From: James Thorne <jthorne@greenintl.com>
Sent: Friday, December 15, 2023 3:24 PM
To: Maren Toohill
Subject: RE: Taylor Street Well Stormwater Permit Submission
Attachments: Taylor St Wells Peer Review - Responses_20231215.pdf; Taylor St Wells Peer Review - Responses_20231215.xlsx

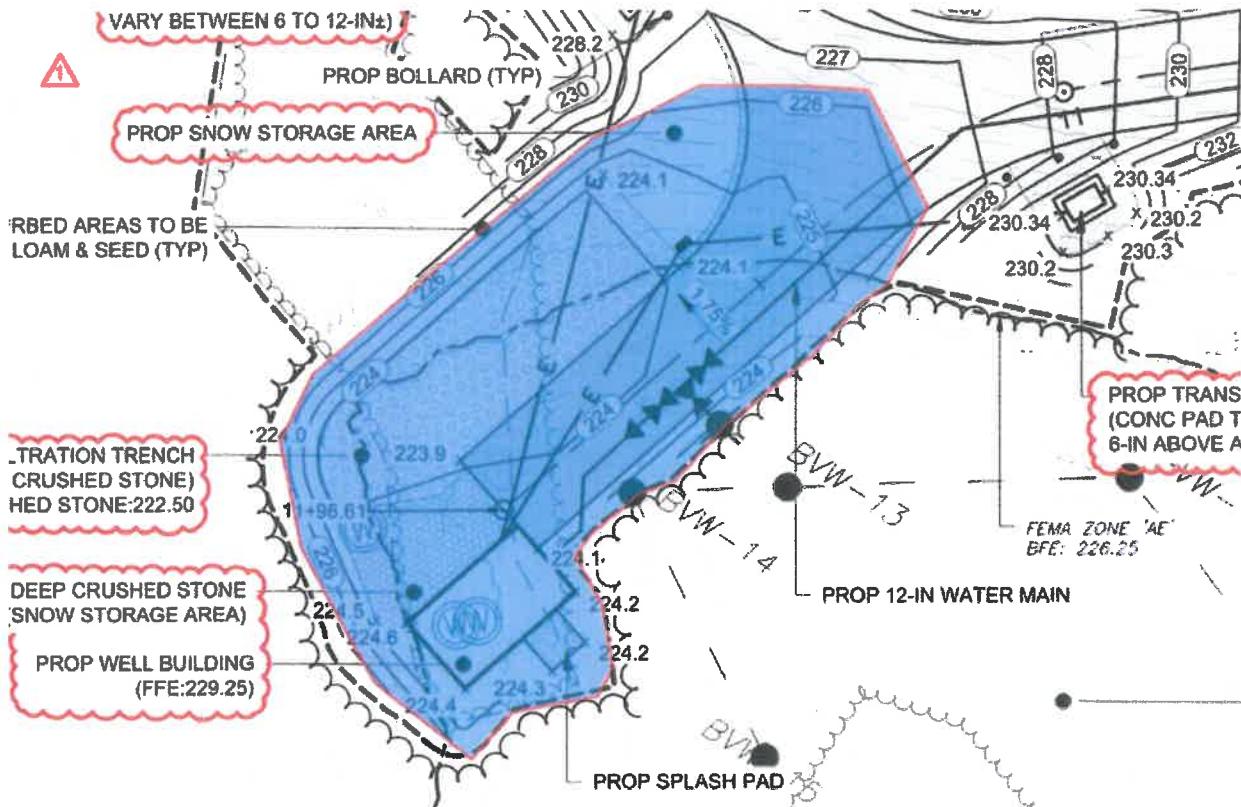
5/5A It looks like their finish floor is much higher than the ground but there are no stairs/ramp shown on the plan. We are not sure if this needs to be ADA compliant or not. Also, the finish floor is above the 100 year flood plain elevation but the area around it is within the proposed flood zone (see area in blue below). We defer to the board if this is ok. I'm not sure but this maybe more within the building department scope of review.
